**TRANSMITTAL OF RESPONSES TO OHIO ENVIRONMENTAL PROTECTION AGENCY
COMMENTS ON THE DRAFT CERTIFICATION DESIGN LETTER AND DRAFT PROJECT
SPECIFIC PLAN FOR AREA 1, PHASE II CERTIFIED FOR REUSE AREAS, TRAP RANGE,
SECTOR 2C, AND SECTOR 3 CERTIFICATION SAMPLING**

**RESPONSES TO OHIO ENVIRONMENTAL PROTECTION AGENCY COMMENTS
ON THE PROJECT SPECIFIC PLAN FOR AREA 1, PHASE II CERTIFIED FOR REUSE
AREAS, TRAP RANGE, SECTOR 2C AND SECTOR 3 CERTIFICATION SAMPLING
(20710-PSP-0009, REVISION A)**

Section #: Figure 4-2

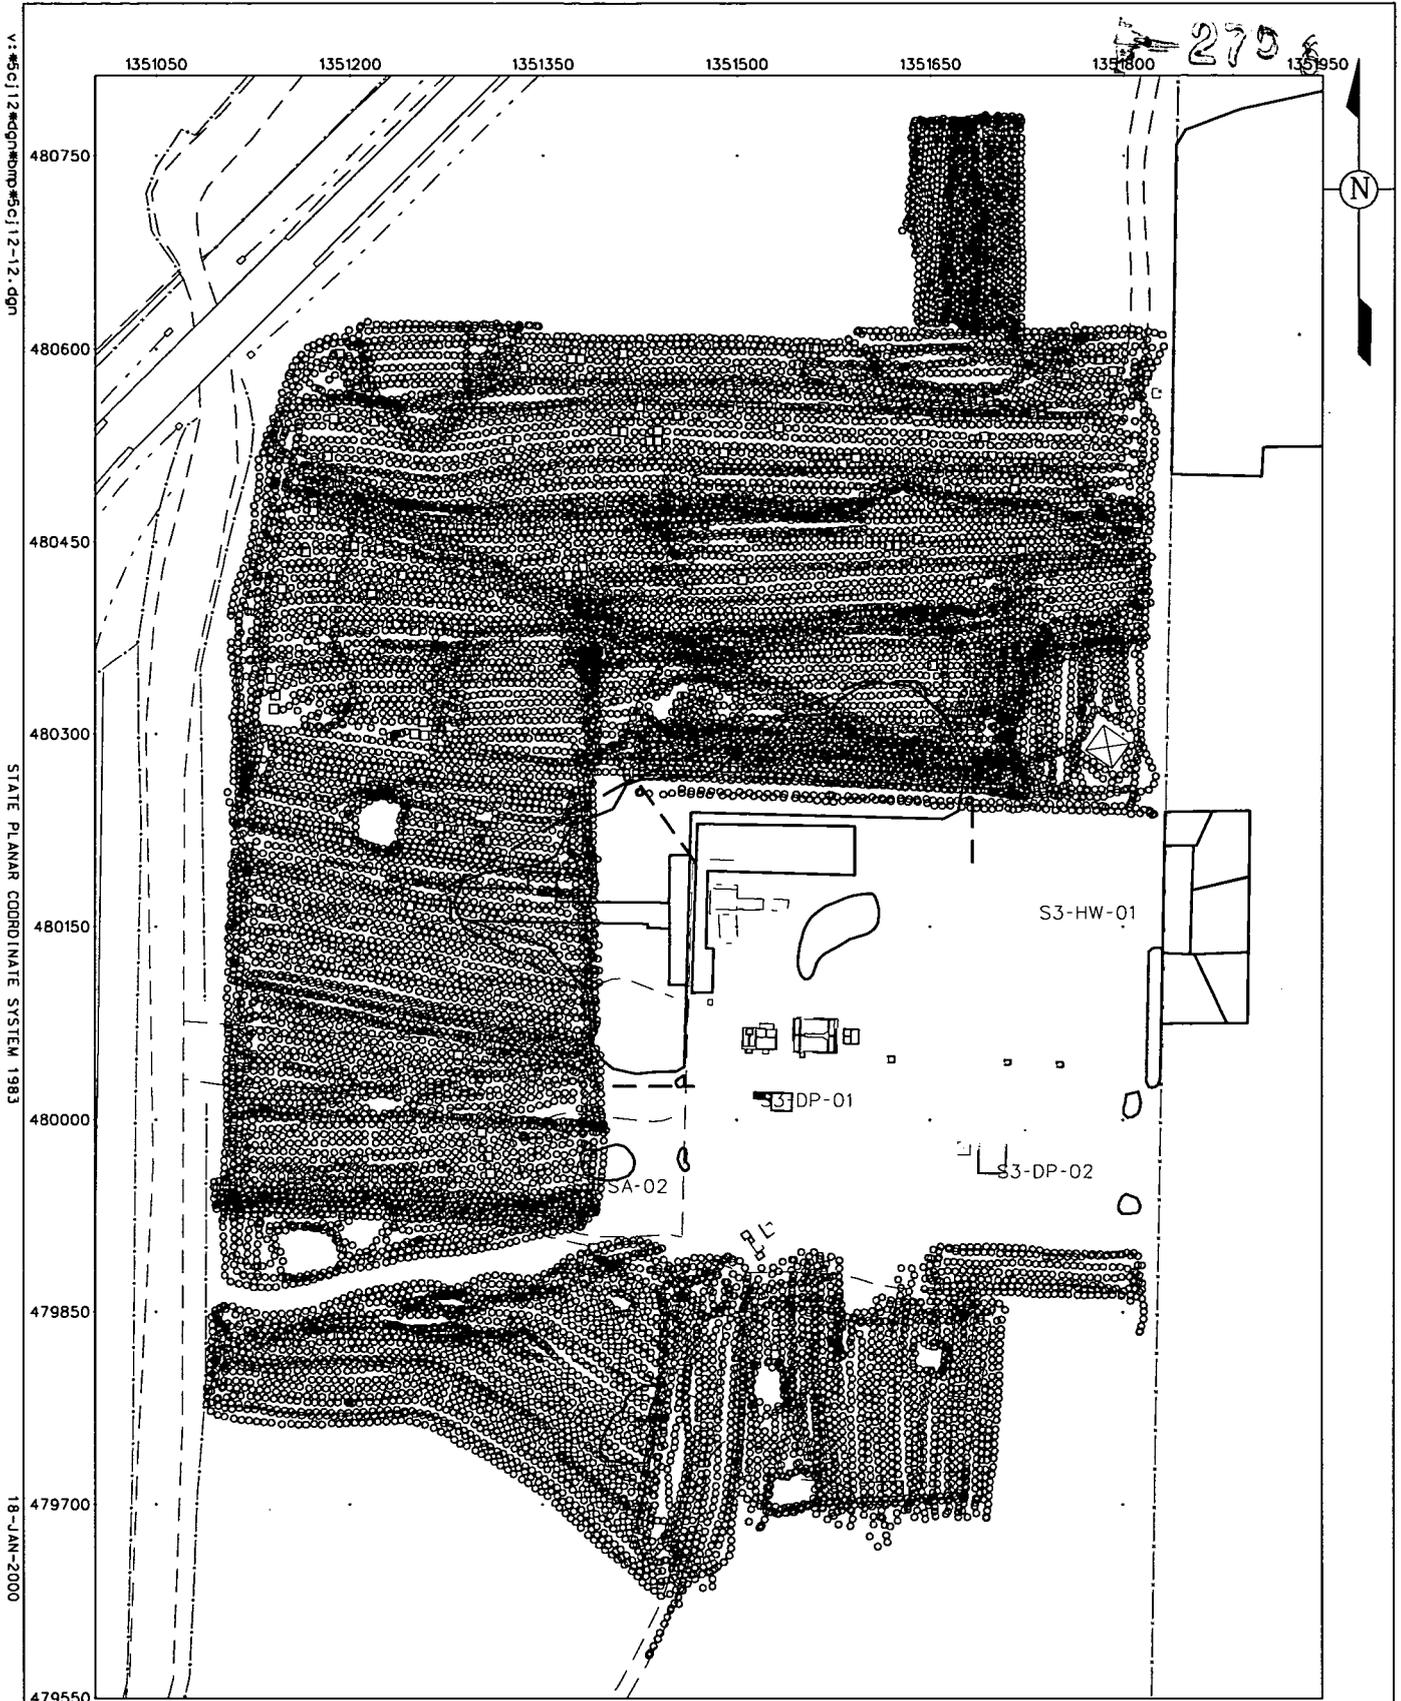
Comment: The CU east of S2-NI-03 and S2-NI-04 is not labeled. Please correct.

Response: The Figure will be clarified to properly identify S2-NI-05.

Action: A revised figure will be provided.

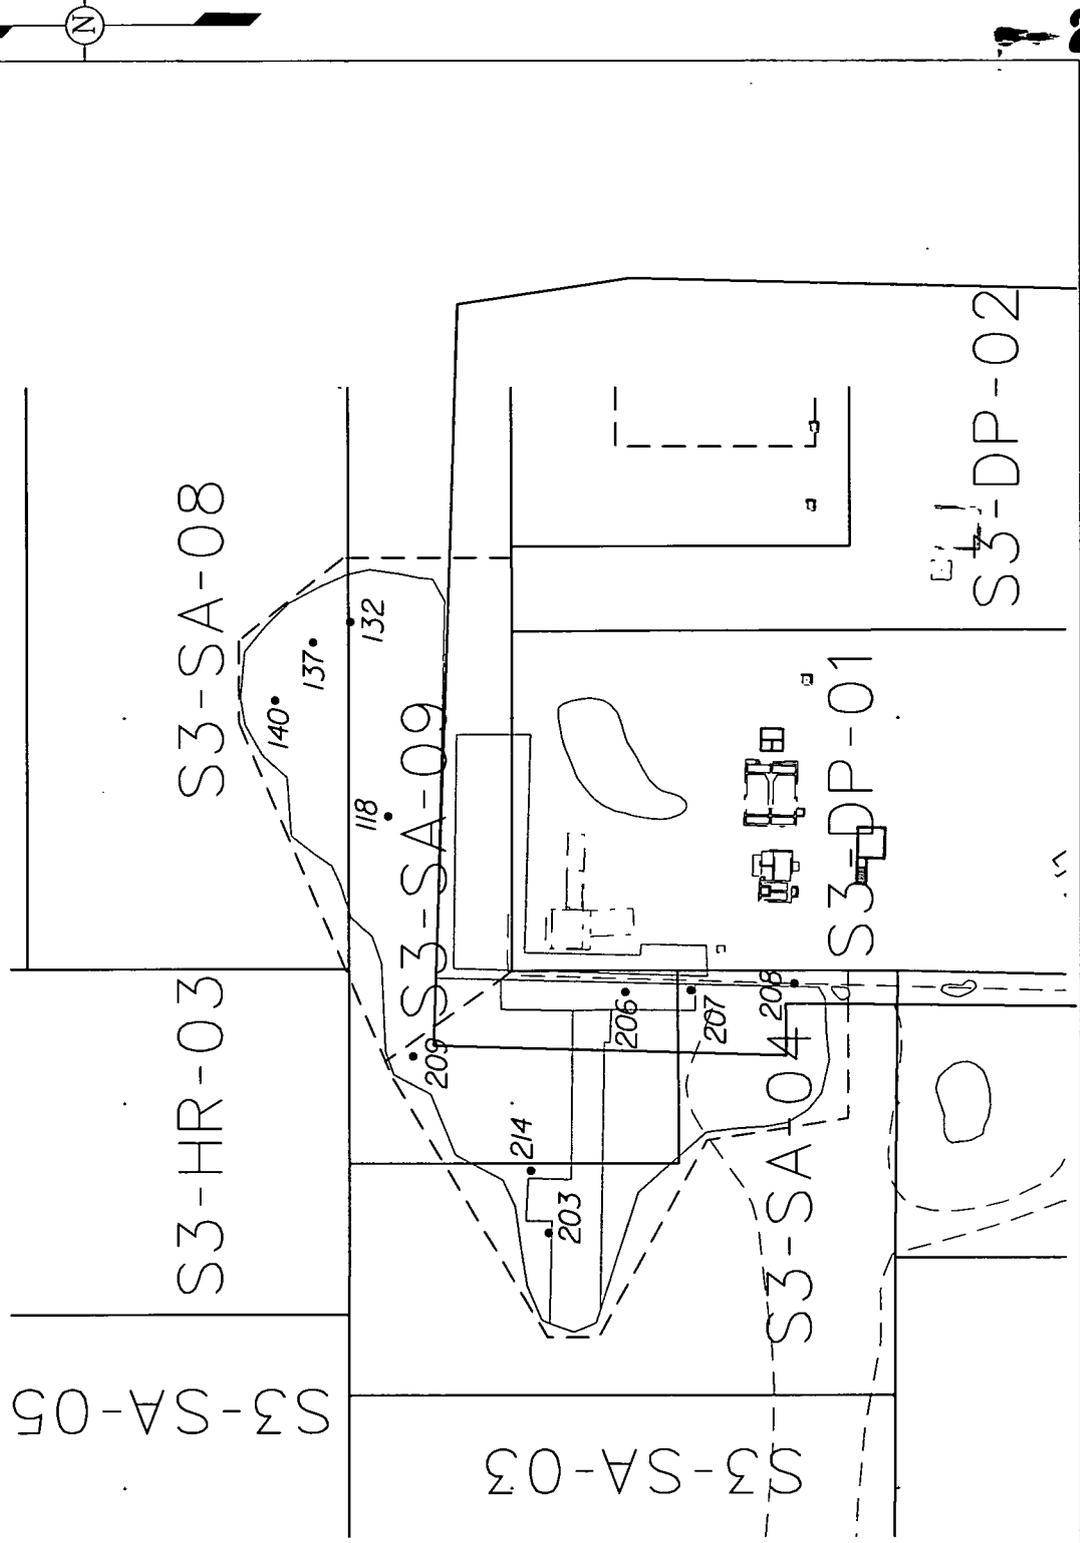
- Comment:
- A) How will the top 6 inches of native soil be determined?
 - B) OEPA does not feel that one sample from each CU that was part of Removal Action 14 is enough. More samples need to be added to ensure all contamination was removed during RA 14. Also, please include a map showing the locations of RA 14 overlaid on the current CUs and sampling locations.
 - C) Has any characterization been done on the fill which was 'from an unknown source'?
 - D) This section needs to state that if contamination is found at depth, the soil will be dug up and resampled.

- Topographical data from 1992 (pre-RA 14) and 1997 (post-RA 14) was compared to current topographical information for RA 14 sample locations (see attached Figure 4 for sample point locations). Excluding points 206, 207, and 208 which were in the deep excavation areas, the difference in the average depth of excavation in the A1PII STP stripping area (based on current data) and the pre-RA 14 excavation (based on 1992 data) where the remaining seven points lie is 1.1 feet. Additionally, the difference in the average depth of excavation in the A1PII STP stripping area (based on current data) and the post-RA 14 excavation (based on 1997 data) where the remaining seven points lie is 0.6 feet. This indicates that the area was not backfilled and has been stripped by 6 inches.

- A) The top of the native soil will be determined in the field by a geologist
- B) The Certification Units (CUs) in and around the former RA 14 area have been reconfigured to more effectively verify that all above FRL material has been removed. The attached map (Figure 4) outlines the new CU boundaries and includes an overlay of the RA 14 excavation limits. Samples will be collected in two intervals (0 to 6-inch and 6 to 12-inch) for the two CUs that cover the RA 14 excavated areas. The location of the sampling points within each CU are shown on the attached map (Figure 3)
- C) As discussed above, the on-property RA 14 excavation areas were not backfilled
- D) If any CU fails certification criteria a plan for removal of the impacted material and resampling will be developed and implemented upon approval of the regulatory agencies.
